| <b>Notice of Allowability</b> | Application No.      | Applicant(s)     |  |
|                               | 10/523,411           | SHIMIZU, HIROSHI |  |

### **EXAMINER'S AMENDMENT**

Hiroshi SHIMIZU  
LENS HOLDING JIG  
Date Filed: February 3, 2005  
Brett S. Sylvester  
10 of 11

Fig. 9

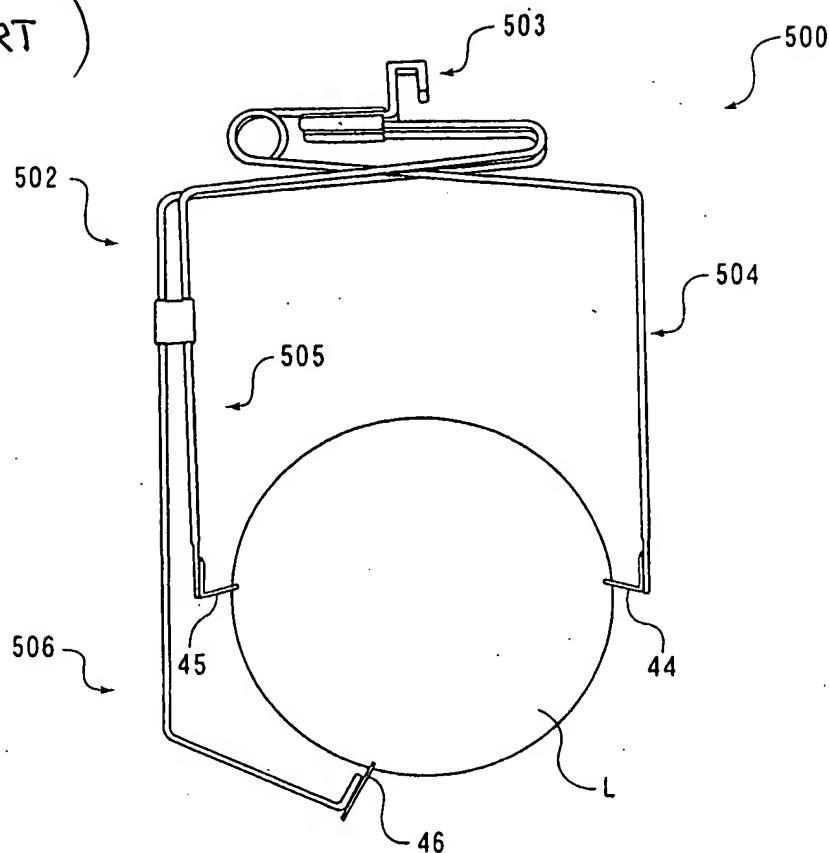
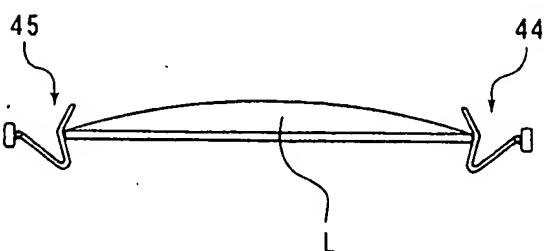
Figs. 9 and 10 have been labeled – PRIOR ART --.

The following is an examiner's statement of reasons for allowance: The invention of the independent claim 1 (Fig. 1) is similar to the invention of the prior art (Figs. 9 and

10) contained in the present application, except that the prior art fails to teach or fairly suggest the limitation regarding the vertical extension which is to be in contact or highly close to the edge of the lens. With this characteristic in place, a solution film is prevented from occurring (see page 7, lines 5-8). This is an improvement over the prior art. As regards the embodiment of independent claim 7, the improvement can be achieved by a new type of lower side holder as given in last four lines of the claim, with the improvement being the reduction of amount of solution to be gathered on the lens (see page 8, lines 13-18).

( PRIOR ART )
